DATE BROUGHT IN: 2/28/01
CHECK #: 3198 AMOUNT: 1340⁰⁰
DATE TO BE CHECKED IN BY: 3/2/01
PROJECT/LOCATION: White Willows Fil #1

REVIEW COMMENT RESPONSES

Where is skyler?
 In access together
 on Florida.
 Access along drain
 ditch

**WHITE WILLOWS SUBDIVISION FILING ONE
TRACT A LAYOUT AND LANDSCAPING PLAN**

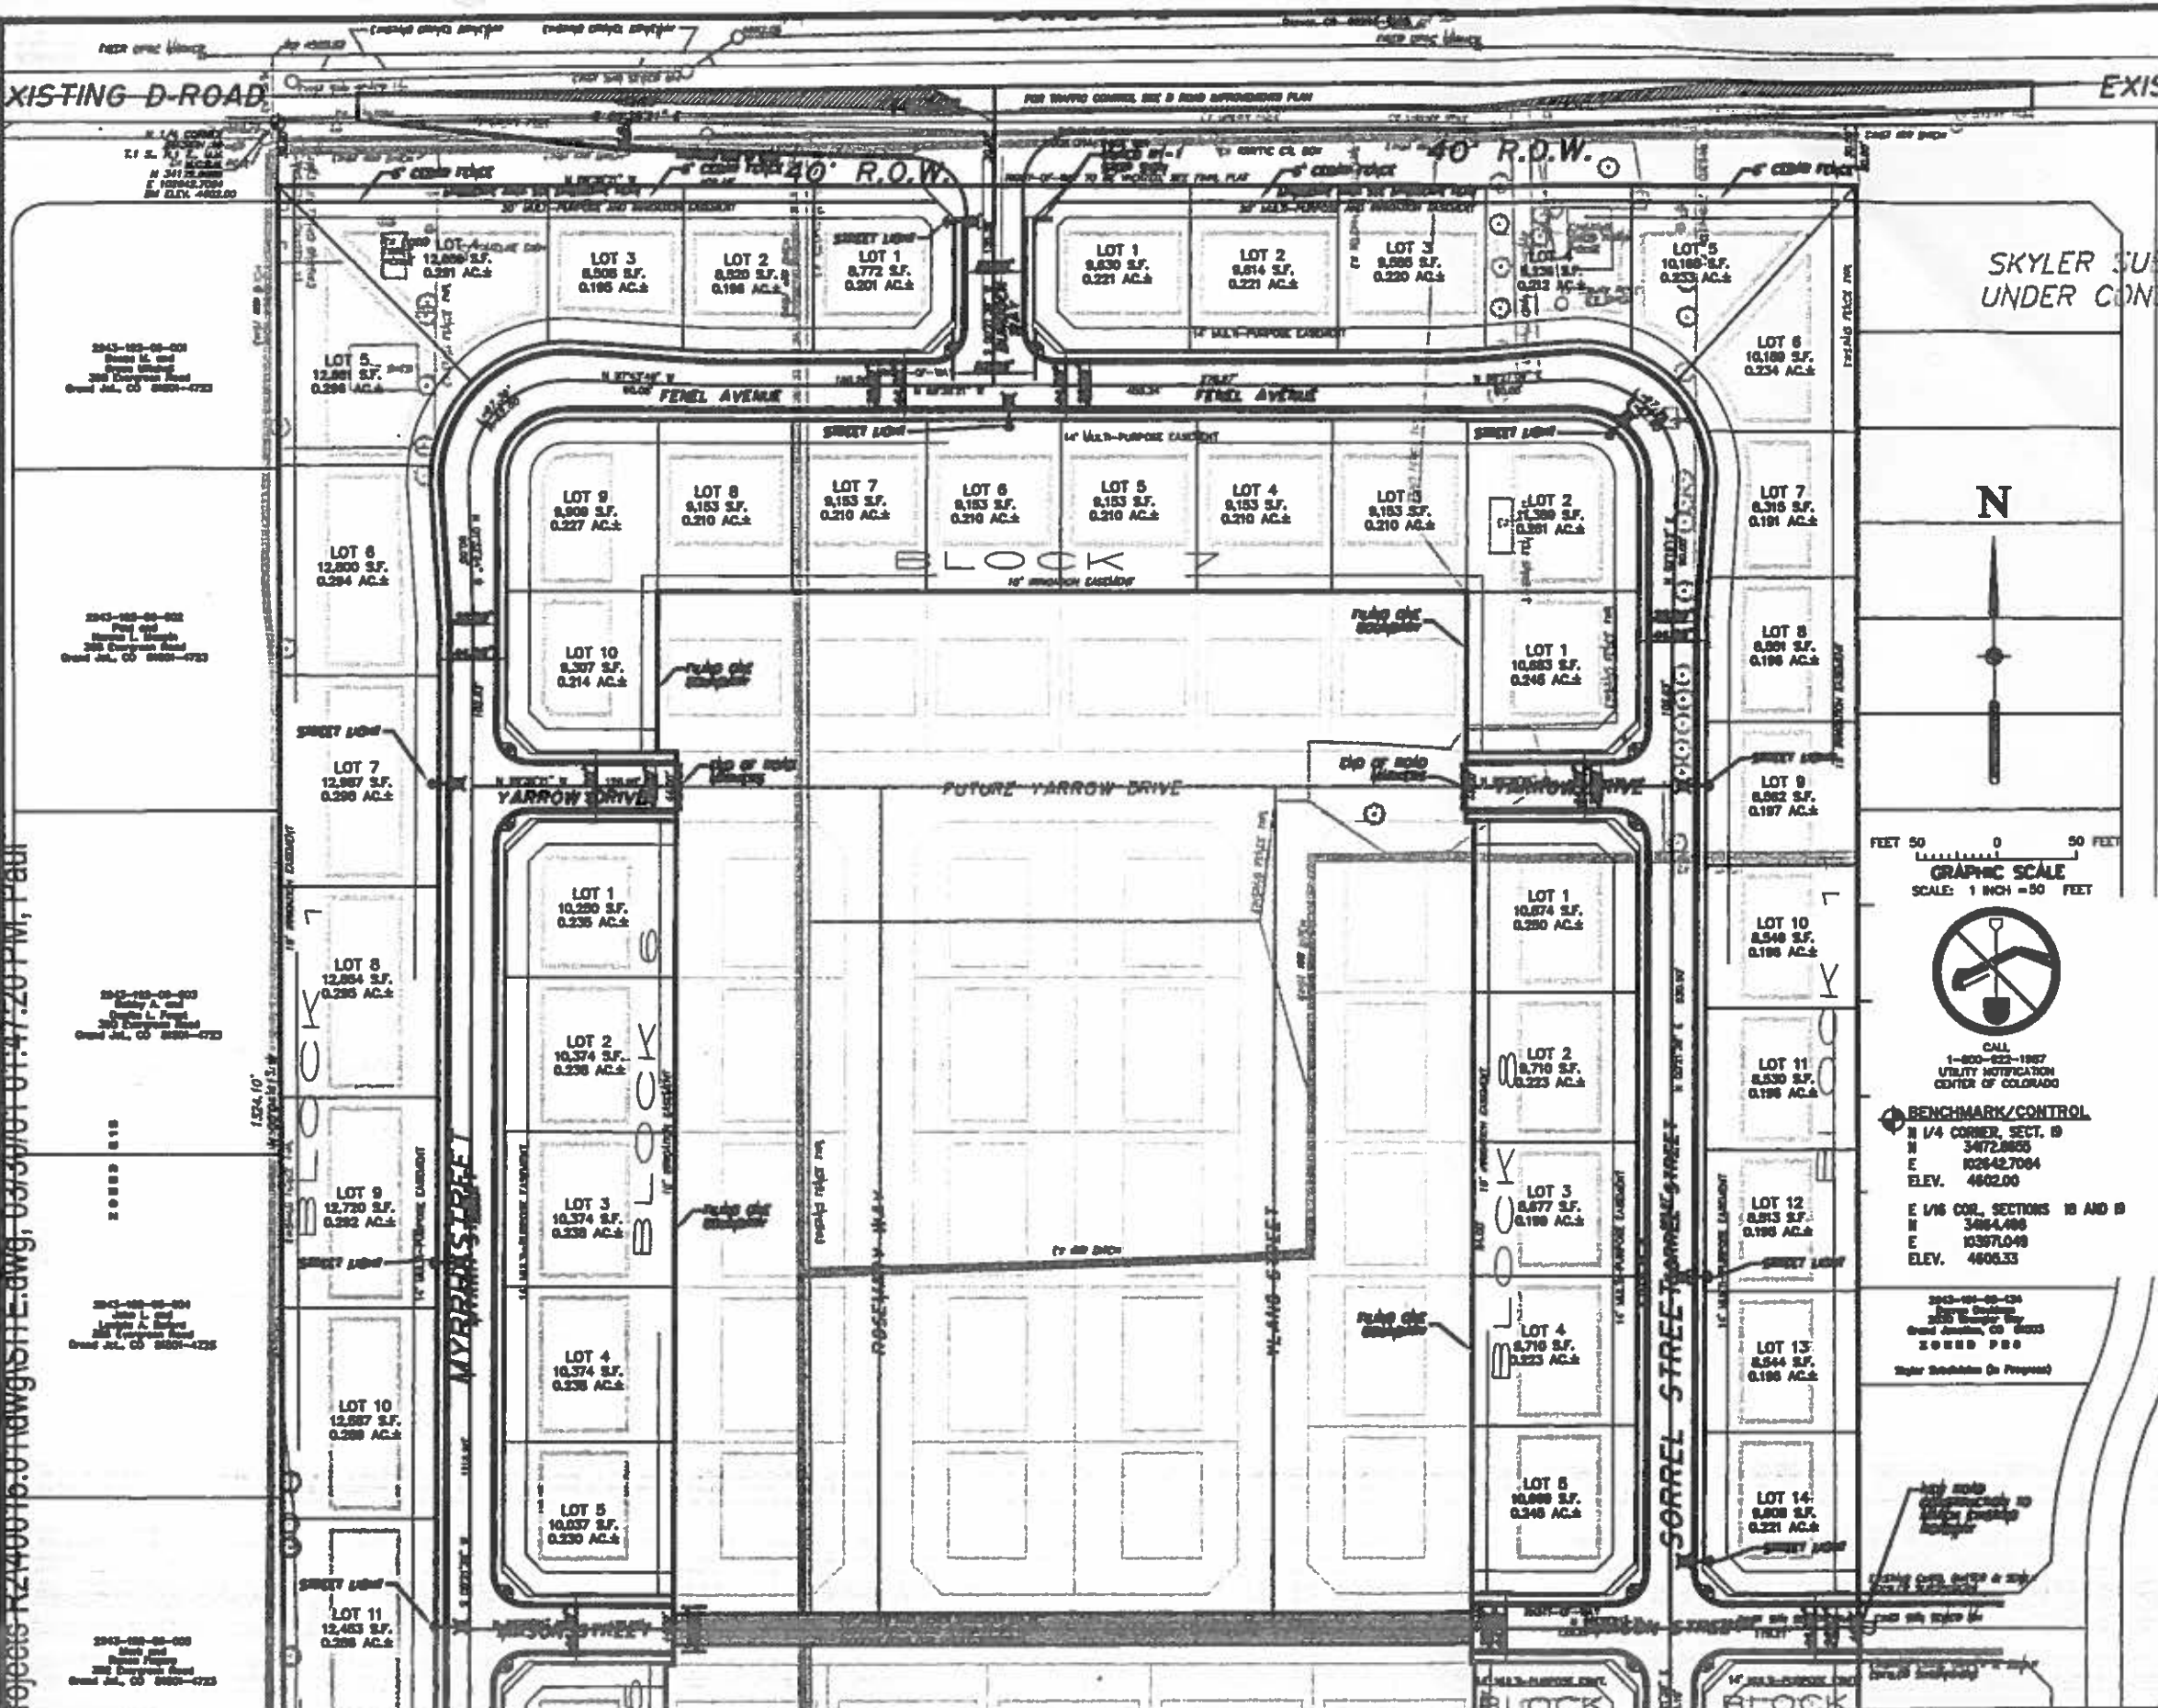
1. Change note 7 on sheet C-45 to eliminate reference to 25 and F ½ Road and to include a weed barrier and gravel to the area between the 5' concrete walk and the rear property line of block 12.
2. Add a note to sheet C-44 to include a weed barrier and gravel in the landscape easement along D Road.
3. Remove note 6 from plat.
4. Submit an executed Development Improvements Agreement with a financial guarantee (or a plat hold option) prior to the pre-construction meeting.
5. Peter Krick will review plat and comments on it will be forwarded at a later date.

1. Note 7 (sheet C-45) has been changed and a weed barrier and gravel have been added as requested.
2. A weed barrier and gravel have been added to sheet C-44 as requested.
3. Note 6 has been removed from the plat as requested.
4. A revised DIA will be submitted with guarantee prior to the pre-construction meeting.
5. Please have plat review comments completed as soon as possible.

SCALE: 1" = 50'
SHEET NO. 40N.01.02
DATE: 03-30-01
SHEET NO. C-8 OF 47

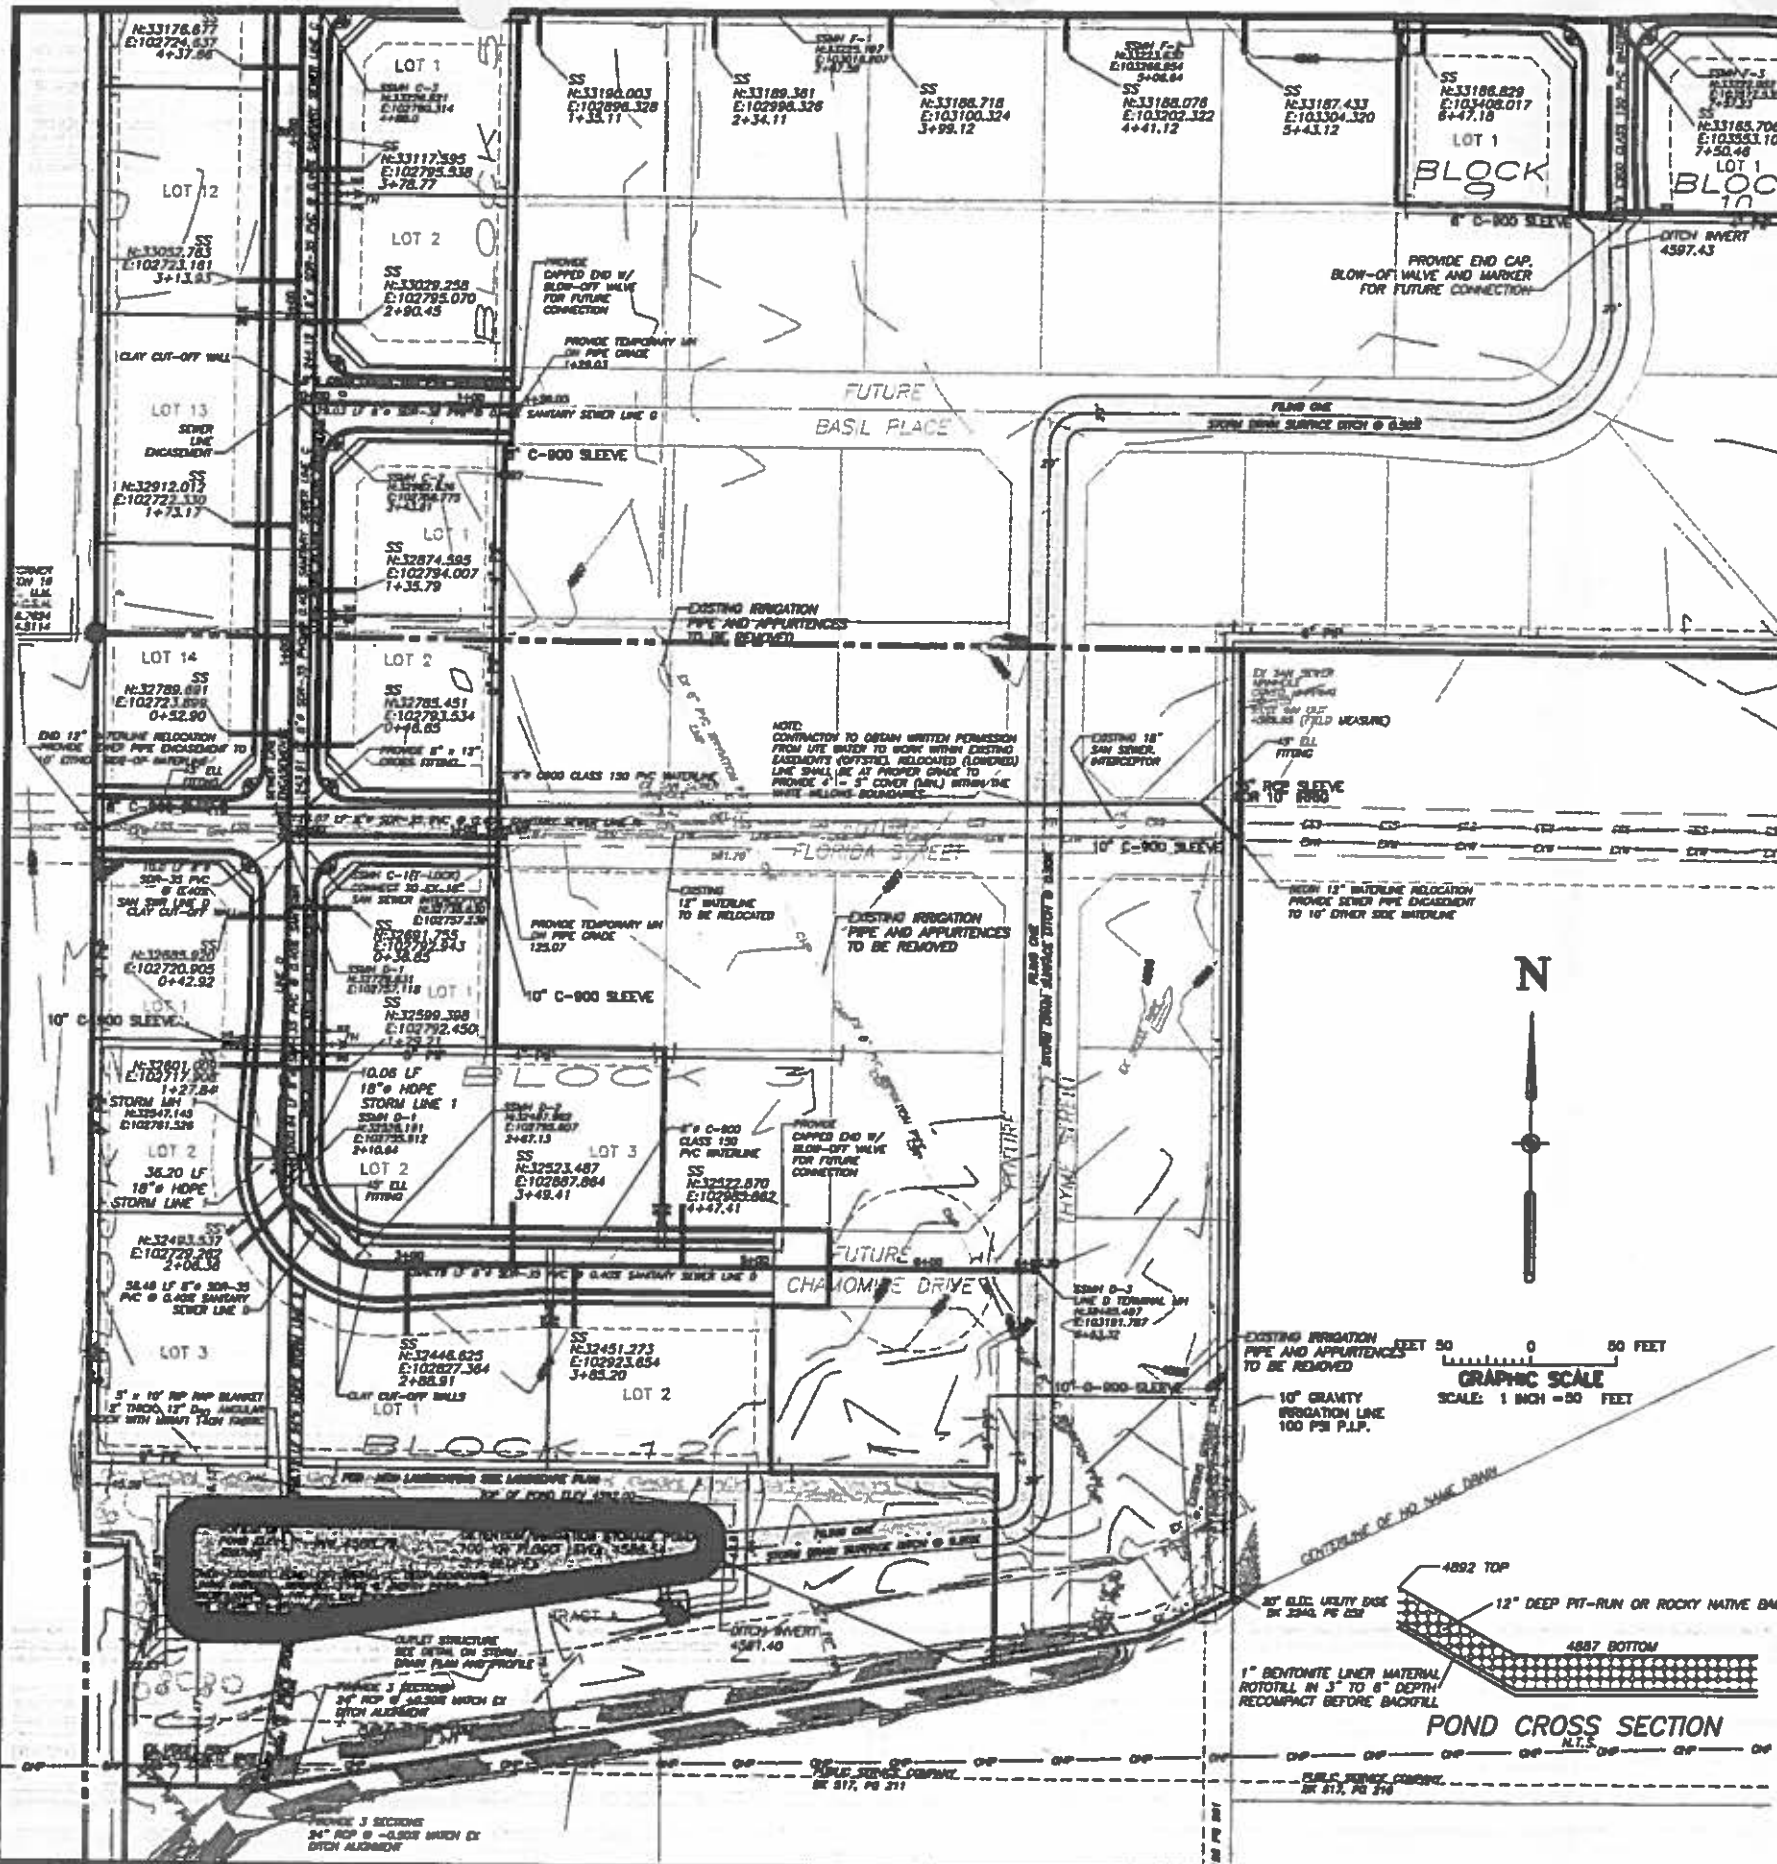
16. Directional flow arrows should be added to the Utility Composite and Plan portions of Plan and Profile Sheets.
17. Sewerline A is incorrectly labeled as line D on Sheets C-8 and C-10 in the descriptive note for MH-A1. Also, this note is cut off on Sheet C-10.

16. Directional flow arrows have been added.
17. The described labeling and note have been corrected.
